RECEIPT DATE: 3-22-18 **ONSITE SEWAGE DISPOSAL SYSTEM** P 502930
 APPROVAL DATE: 04/05/2018 **PERMIT: CONSTRUCTION** A _____
 PROPERTY ADDRESS: 17731 Hardy Road
 SUBDIVISION: Woodcamp Farms LOT: 26 TAX ID: 04-354613
 CONTRACTOR: Sams Creek Construction EMAIL: _____
 CONTRACTOR ADDRESS: 2810 Sams Creek Road, New Windsor MD 21776 PHONE: 443-821-4932
 PROPERTY OWNER: Thomas Locke and Amber Ryan EMAIL: _____
 OWNER ADDRESS: 17731 Hardy Road, Mount Airy, MD 21771 PHONE: _____

WALL CHECK DRAWING
LOT 26
WOODCAMP FARMS

JUSTIFICATION FOR THE
REMOVAL OF SPECIMEN TREES ON LOT 26 OF WOODCAMP FARMS
July 3, 2017

ON SITE SEWAGE DISPOSAL SYSTEM DESIGN PLAN
 LOT 26
 WOODCAMP FARMS
 PLAT NO. 23676

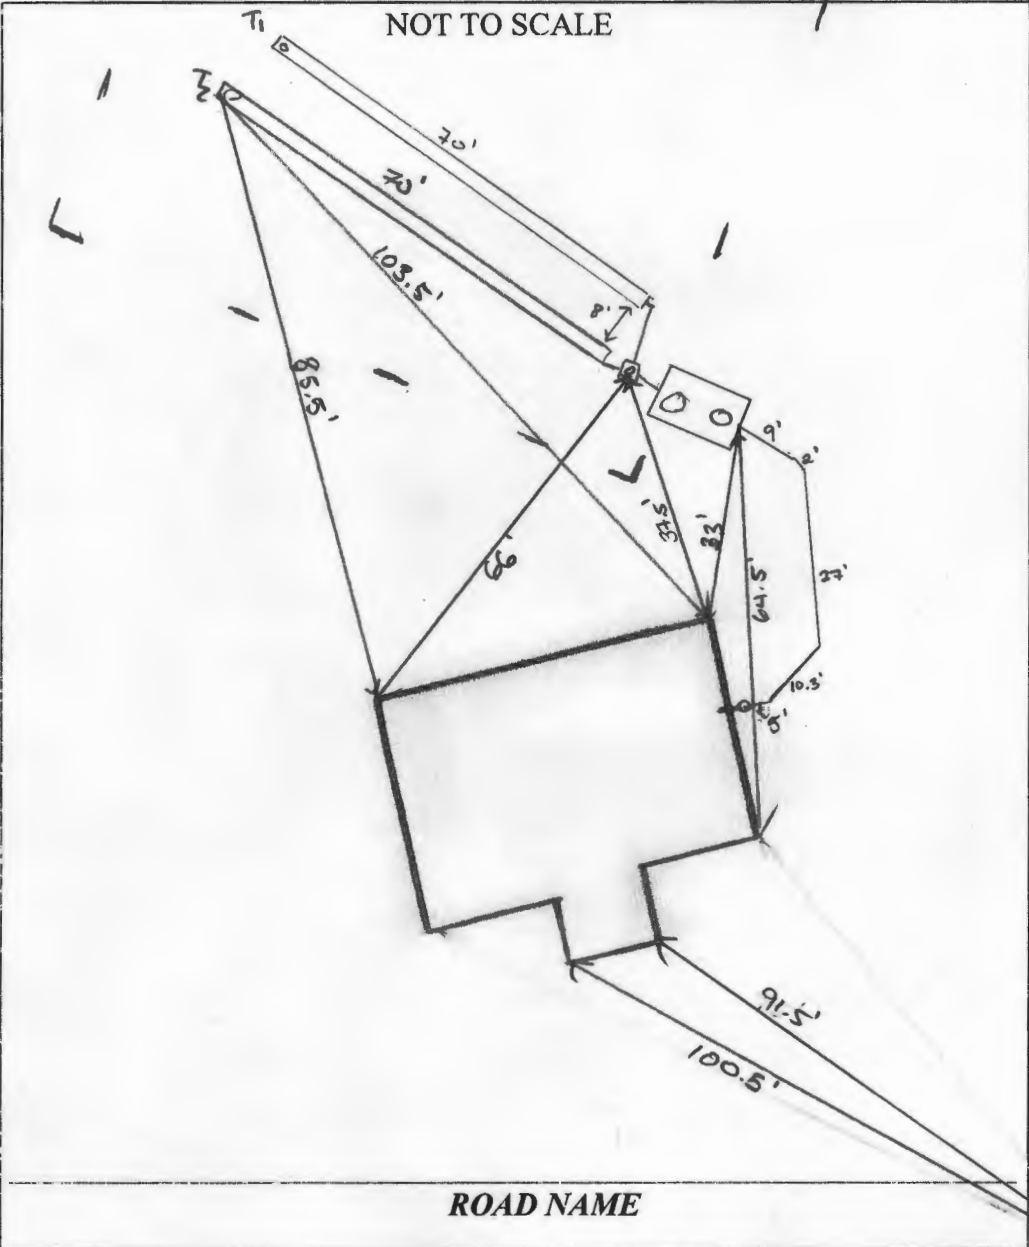
4/3/18 Elevation shot in field. Elevations close to O&D's plan. Some lower grade under footer as indicated on plan. Only 4" difference to meet 4' inlet next to footer. Builder notified of wasted area on upper part. He will let homeowner know. No charges @ this time. Set date per plan. Install 2x 70' trenches per plan. Stone one of them #2 (100)/JC

INSTALLATION: 4/3/2018 (PM) Tank pit dug. 4/4/2018 House connection installed. Influent line to ST. completed. ST. set. T₁ partially complete. Needs stone, perforated pipe, and obs port. 4/5/2018 Trench 1 and Trench 2 (upper) complete. ok on backfill. D Box leveled. Corrective action - Inlet baffle needs to extend 16" below invert. 4/5/2018 (PM) Photo from contractor. C.O. corrected. (P)

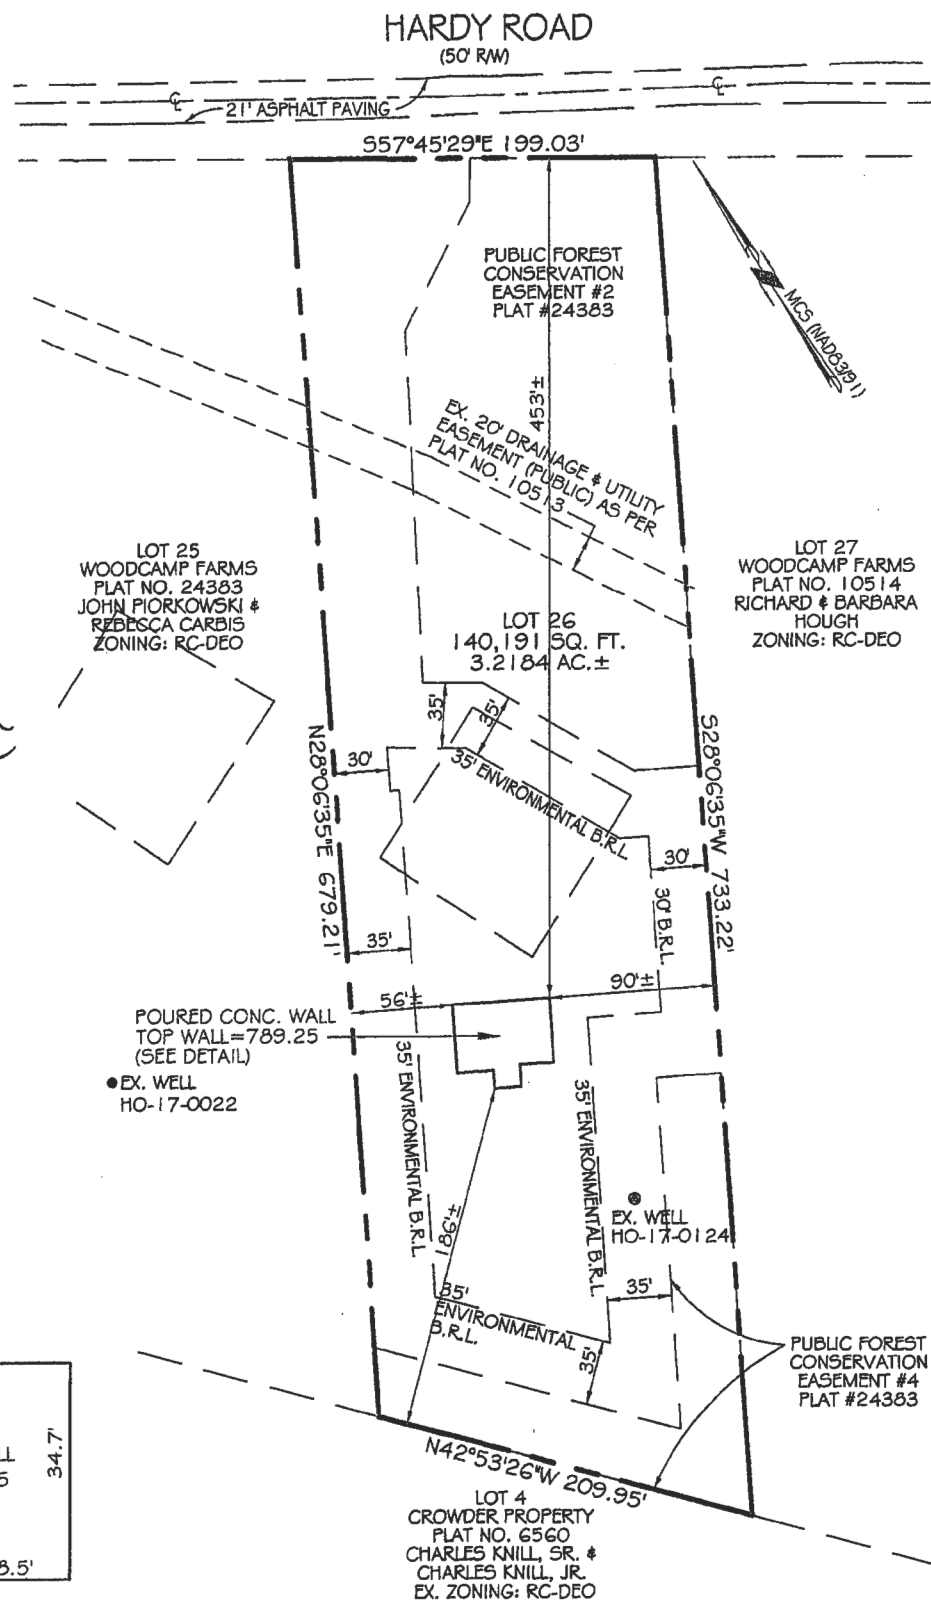
Wall Check not in file. Copy sent over not to scale.

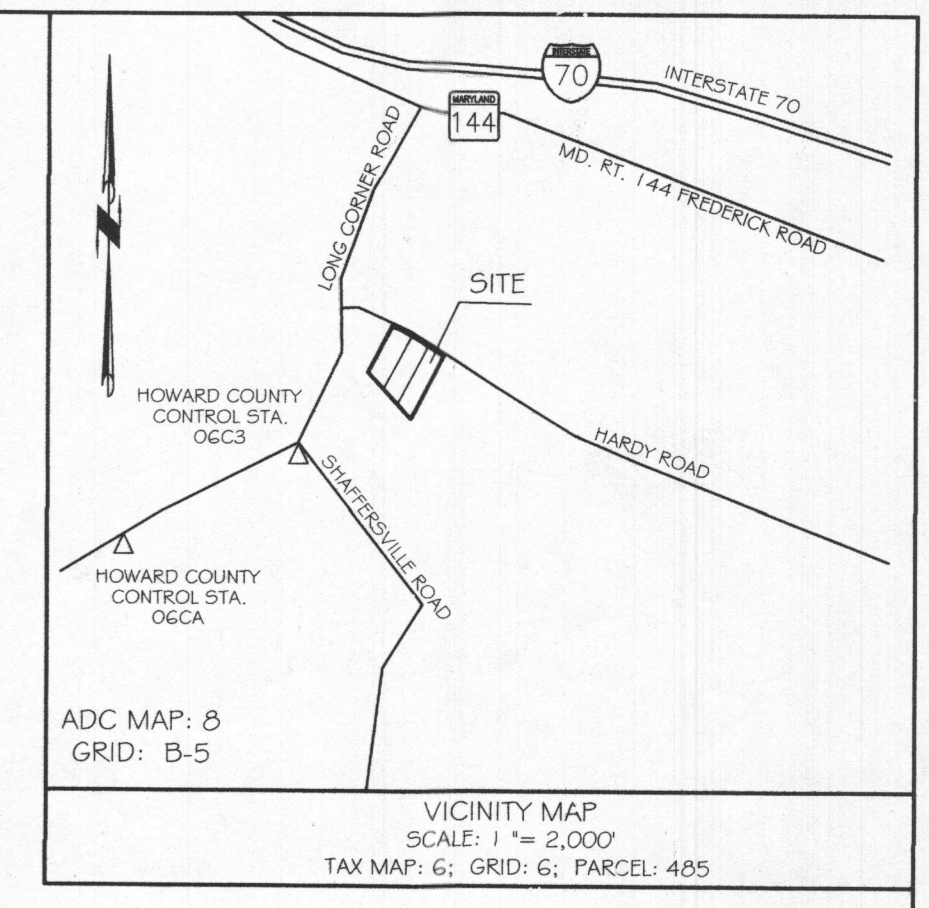
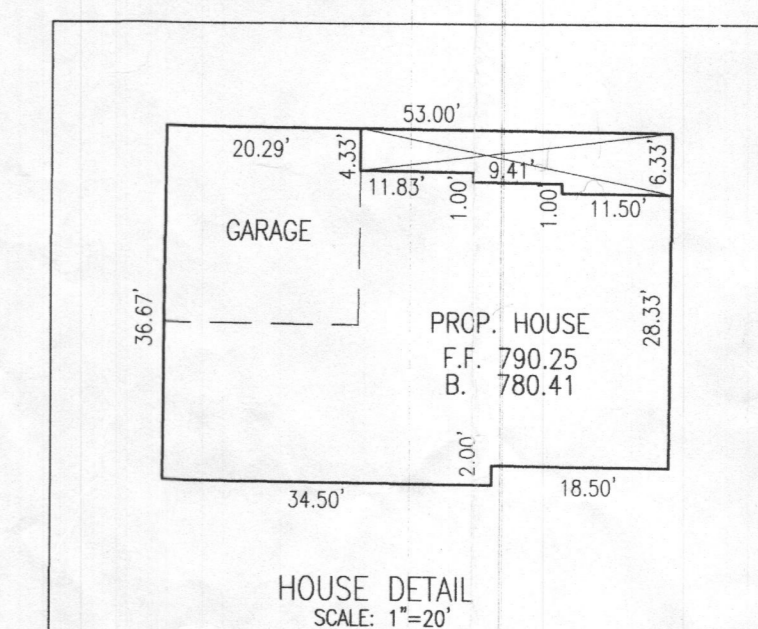
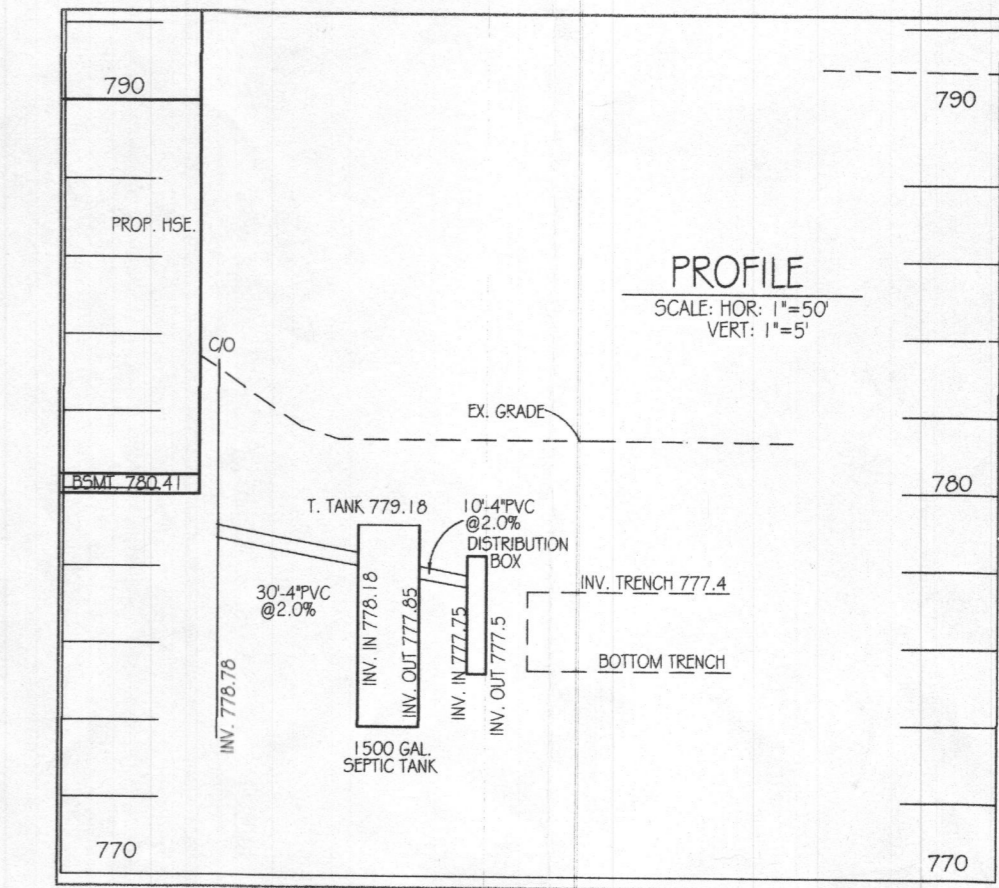
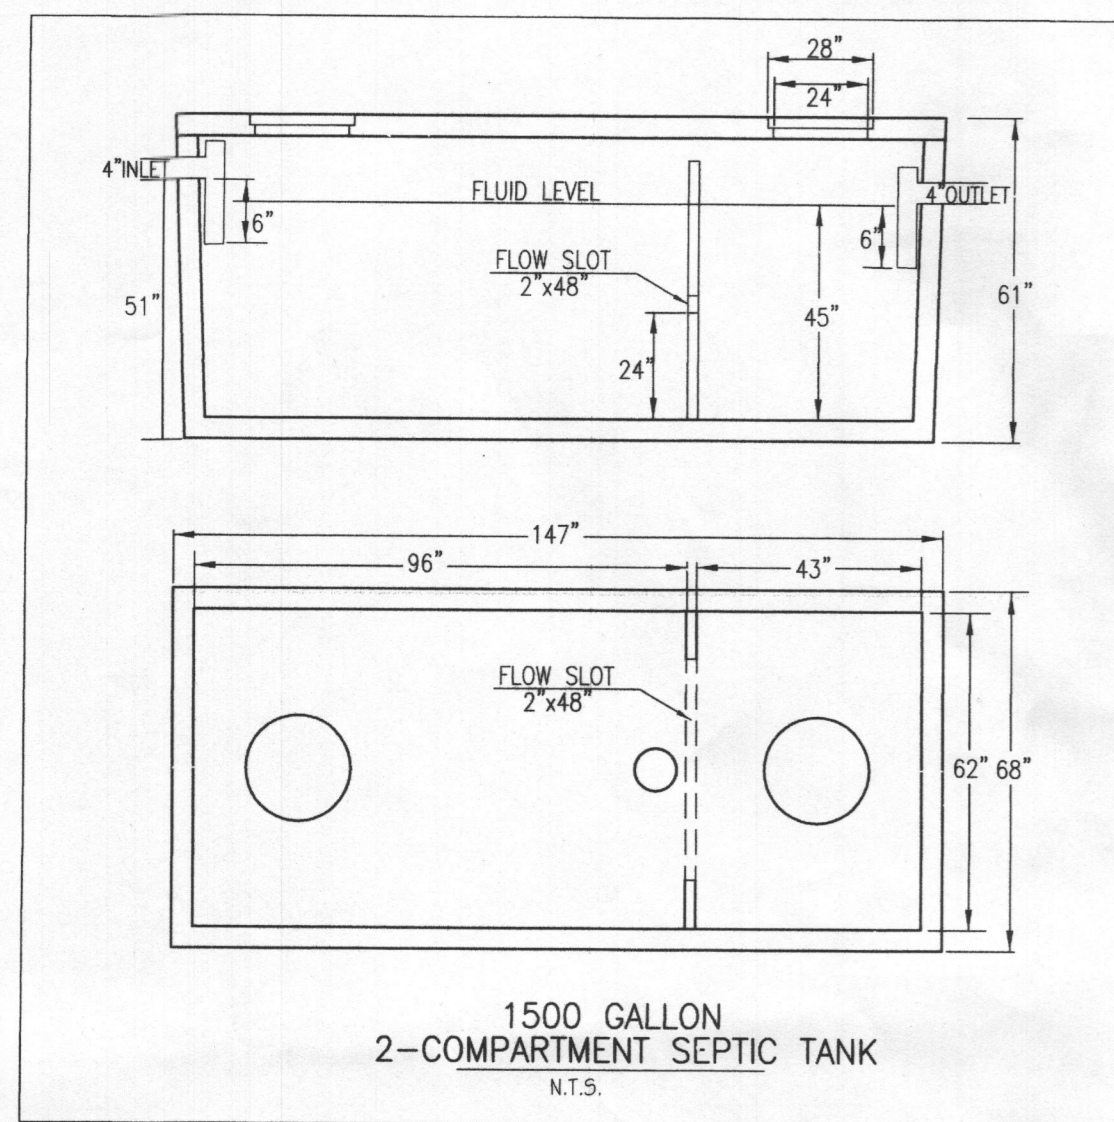
Specimen #2. A 32" dbh Hickory sp. The tree stands 15' from the front door of the proposed house and is adjacent to the approved septic field. Health is fair. Significant competition from surrounding trees is seen in the canopy. The canopy is thin. The tree will be effected by significant wind throw after removal of trees for the adjacent septic field and house. Removal is recommended for safety to the proposed house.

Specimen #3. A 32" dbh Hickory sp. Health is fair . The tree stands 64' from the corner of the proposed house. Significant competition is seen in the canopy by surrounding trees. The canopy is thin. Removal of surrounding trees for house construction will also subject the tree to wind throw, making its removal important for safety reasons. Removal is also recommended due its proximity to the house and to the well box and for root removal and water table fluctuation as a result of construction.

In summary, two of three specimen trees require removal for house construction and establishment of the well box.

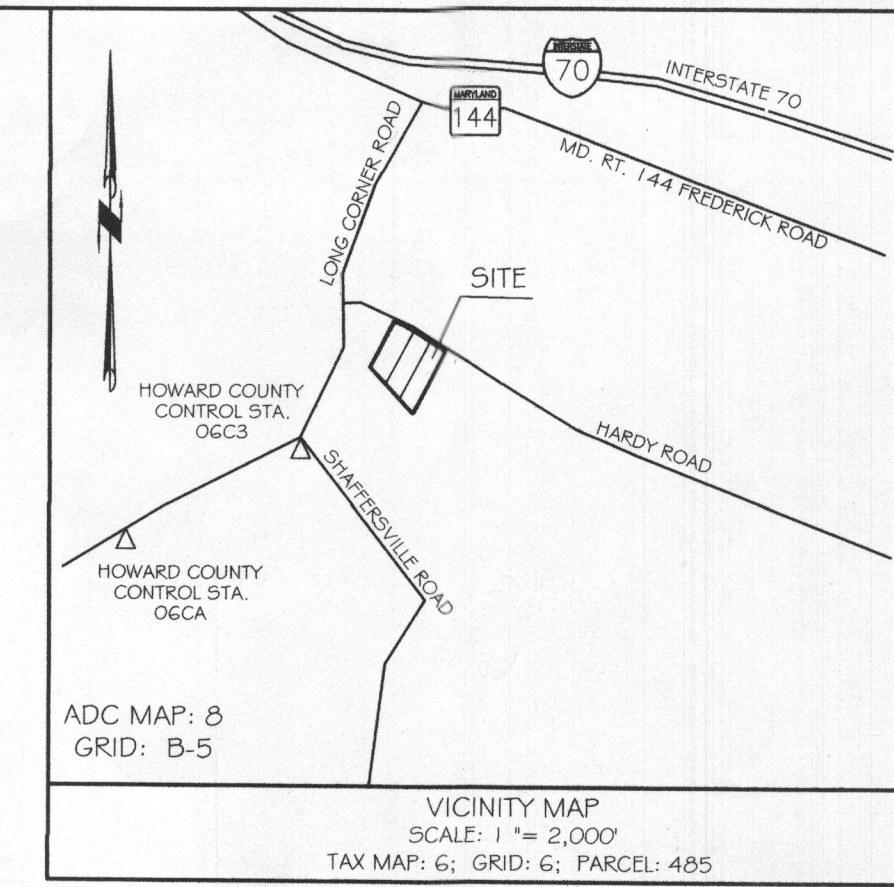
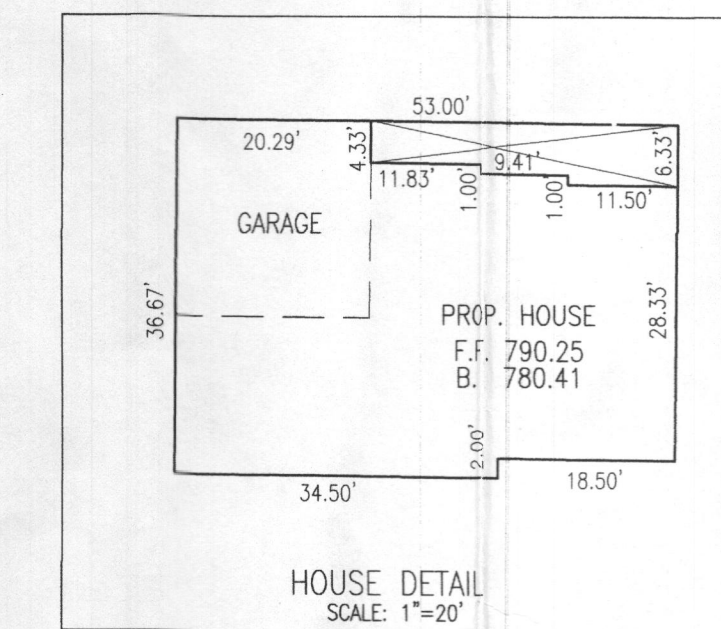
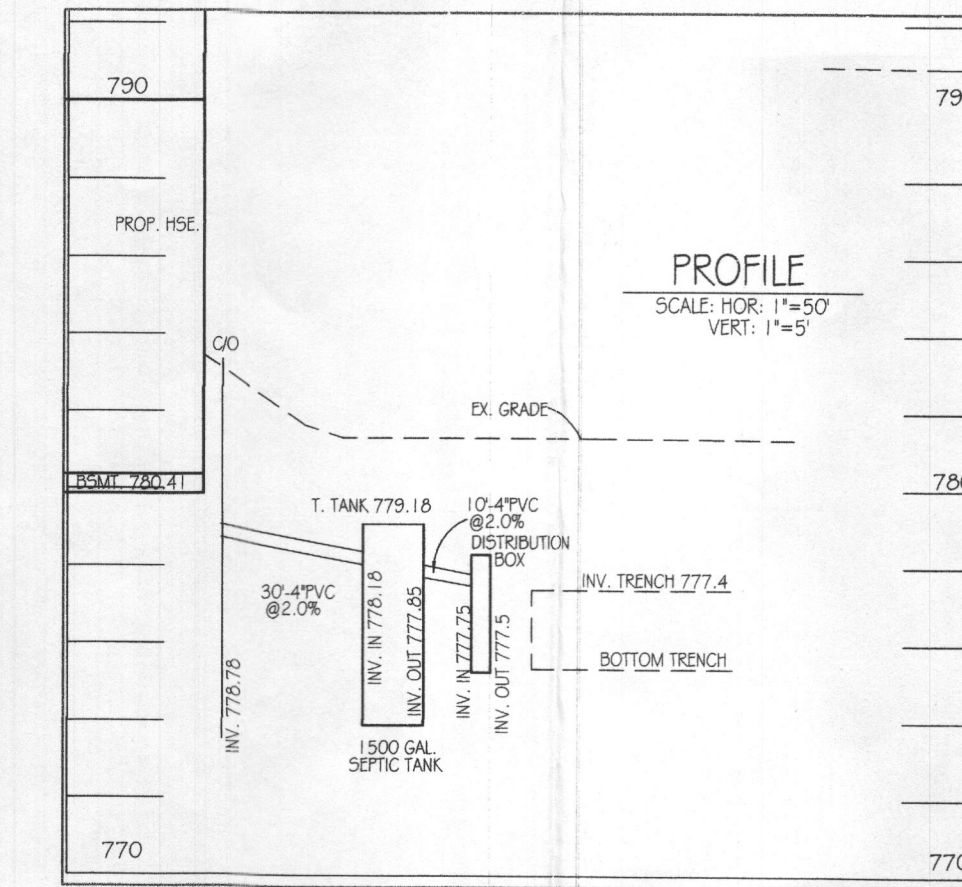
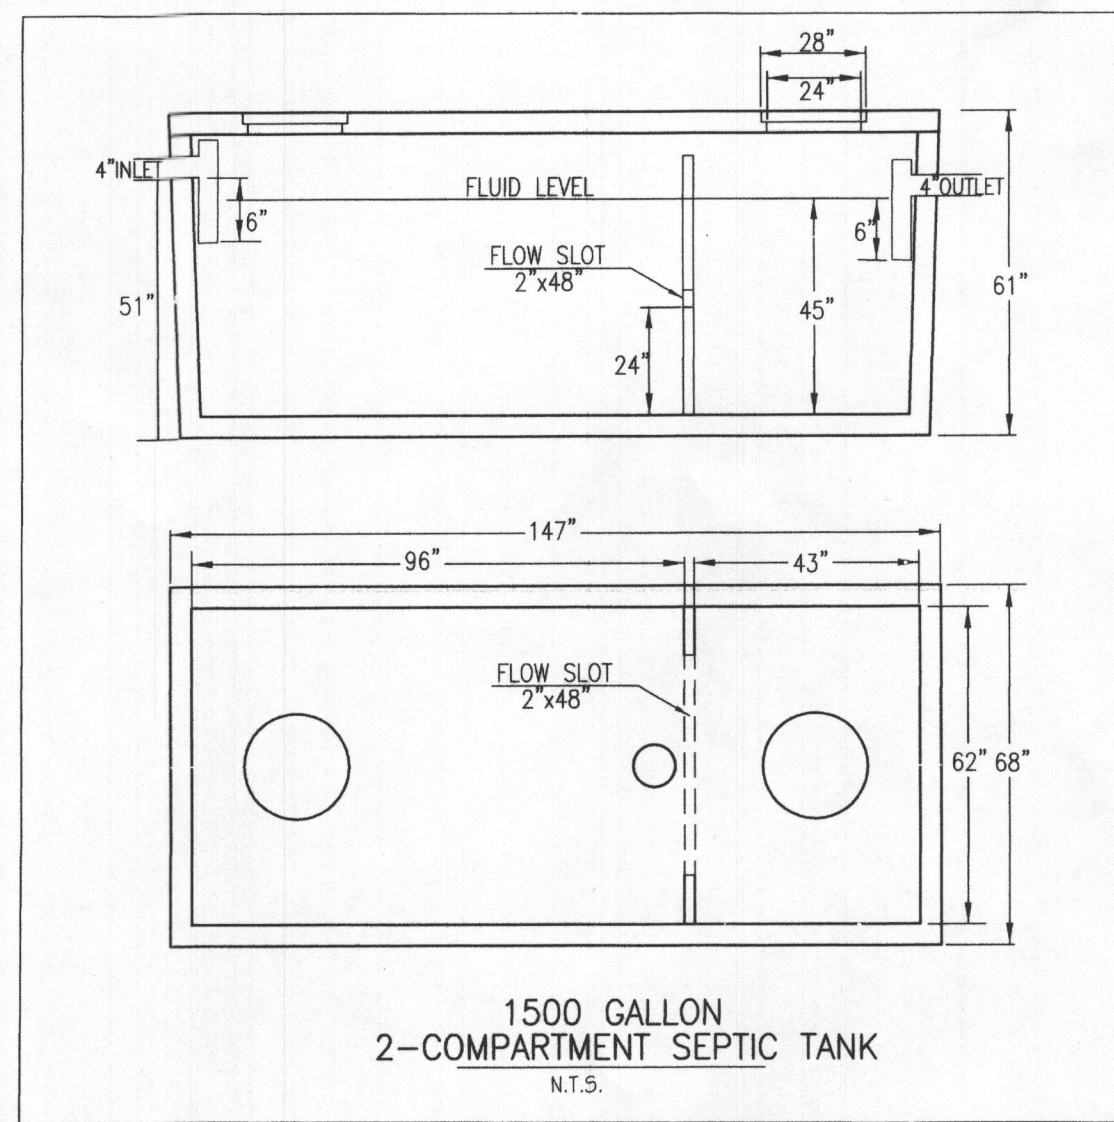
Attached, please find a copy of the septic specs for Woodcamp Farms, Lots 25 & 26. Note, the OSDS Plan must show a well box or 2 alternate well sites. Should the existing well site on the approved plan result in dry hole, the existing plan would need to be revised. An engineer could come in to the office and redline the plan to show a well box or new well sites in an agreed upon location.
